22417
3 of 7

CITY OF SANIBEL
 BUILDING DEPARTMENT

SITE PLAN
 SCALE 1"=30'

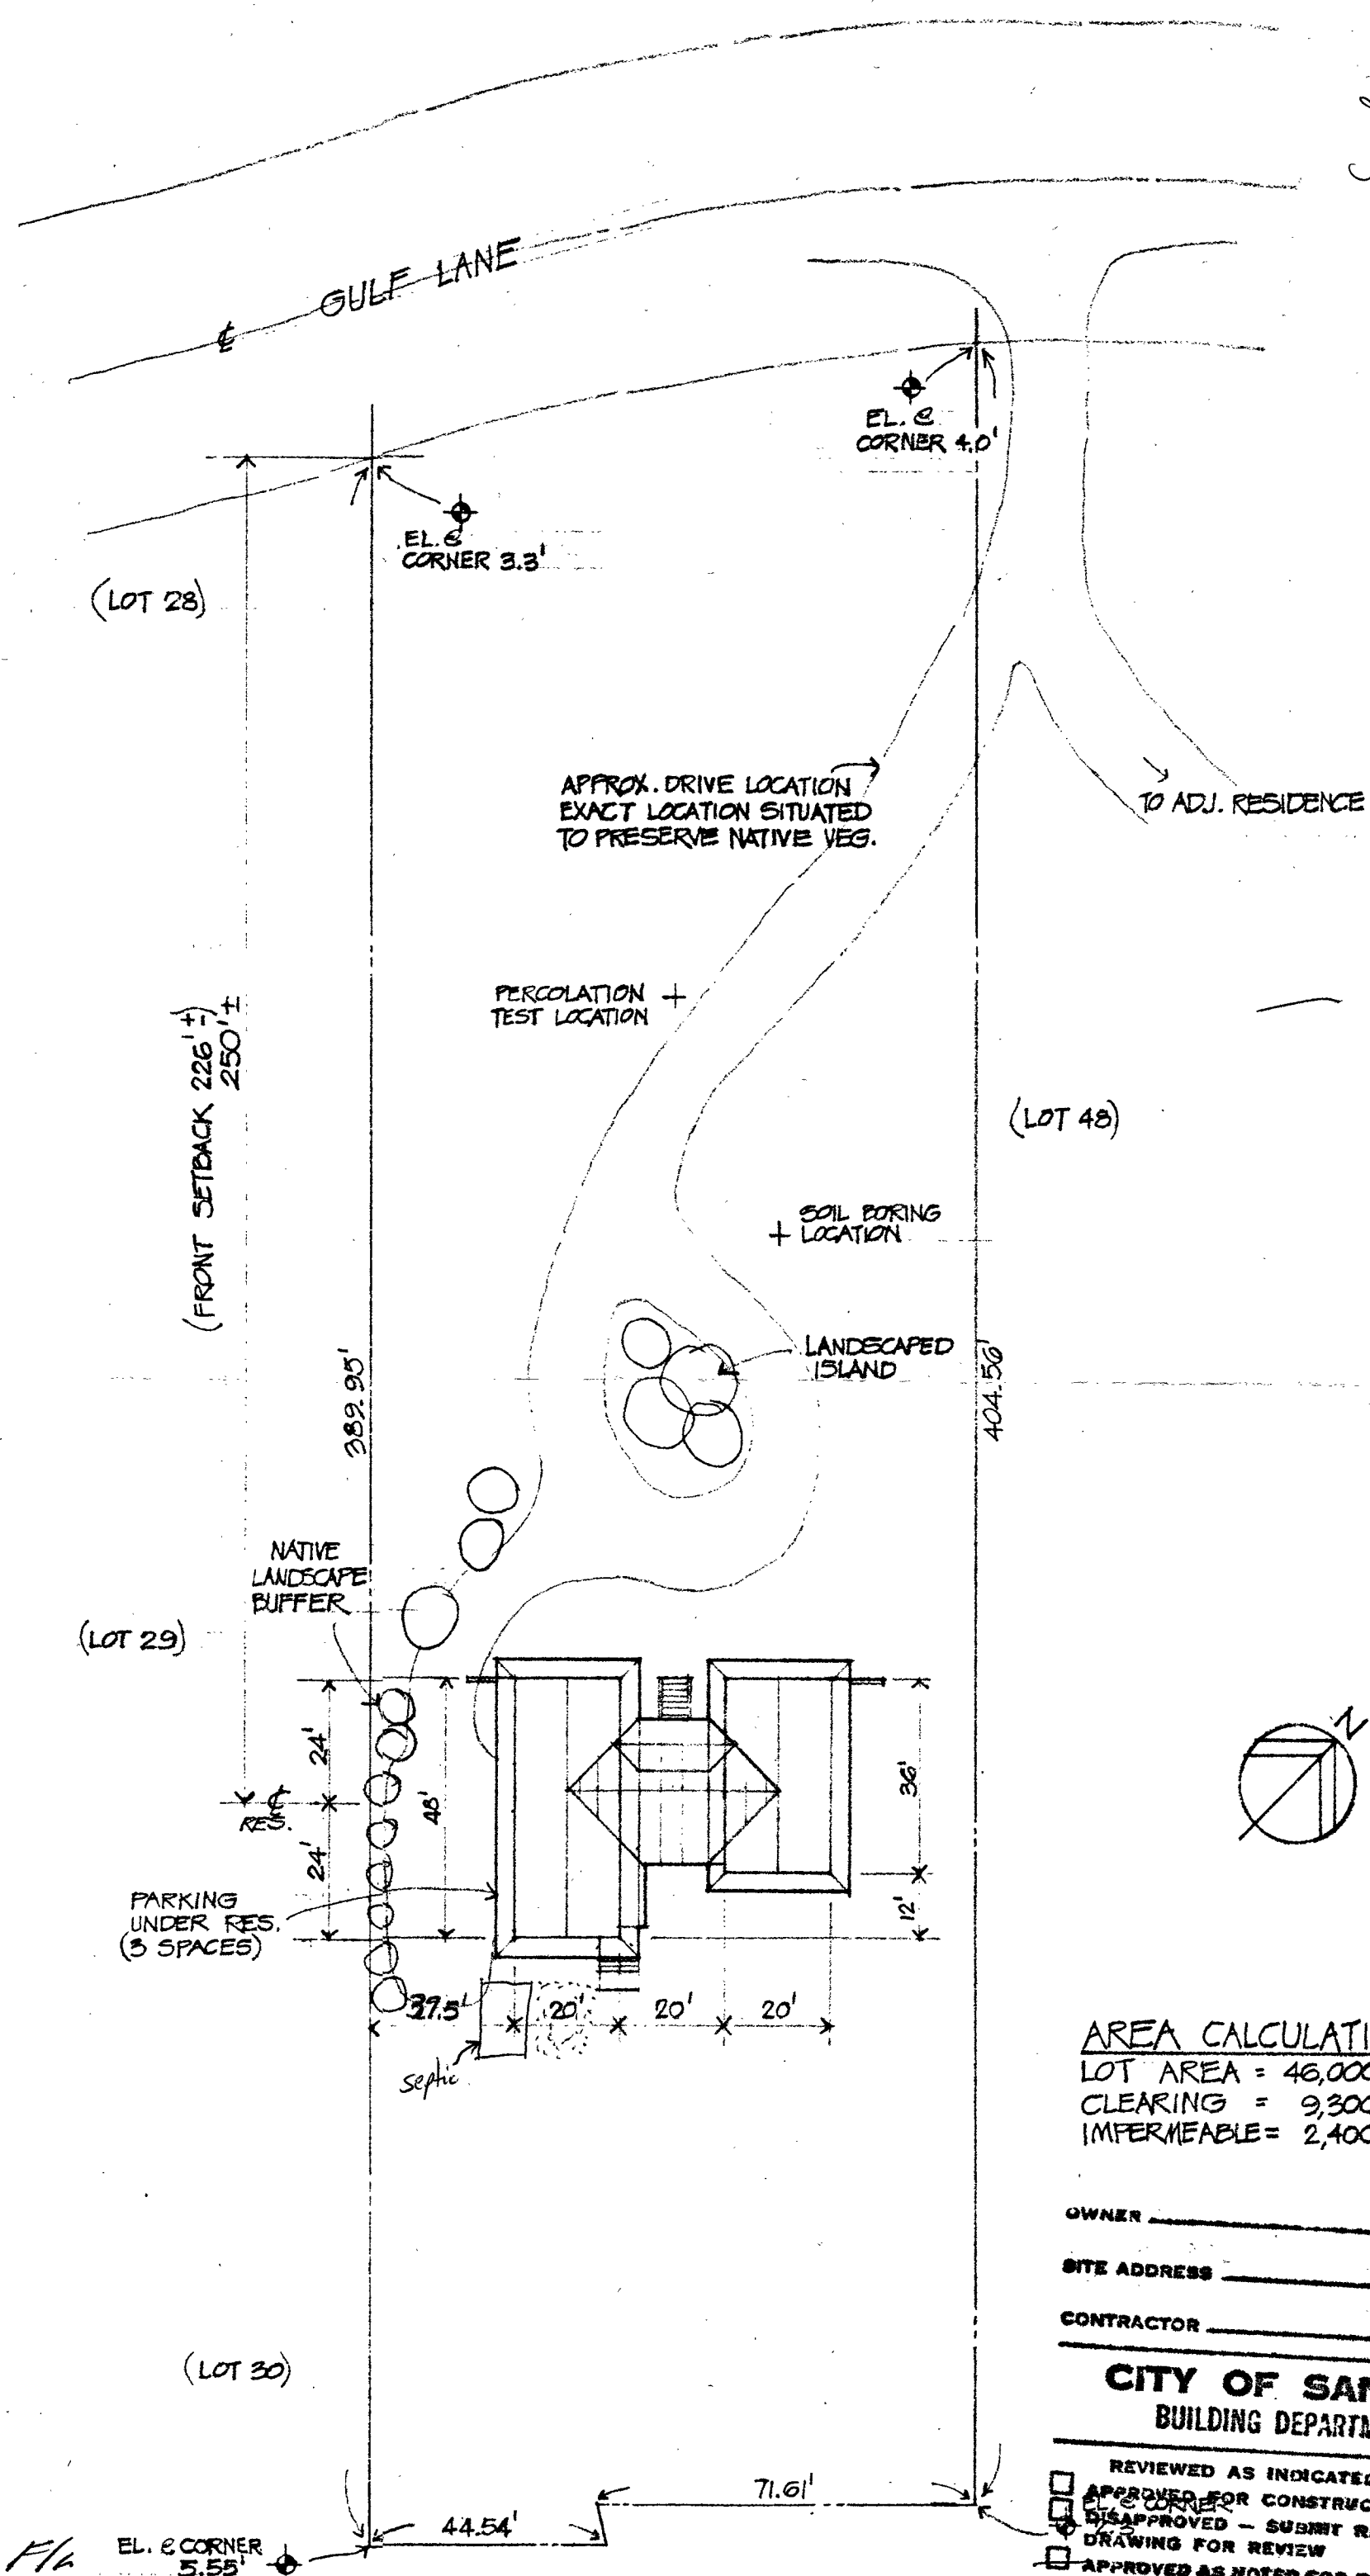
- ① High EFF AC UNIT WITH EER OF 7.2
- ② All Shower Heads 3 GPM. MAX.
- ③ Insulate all Hot Water Lines
- ④ Elevate Electrical Panel to First Habitable Floor
- ⑤ Protect "feeder line" at meter

First Habitable Flr
El. 11' above M.S.L.
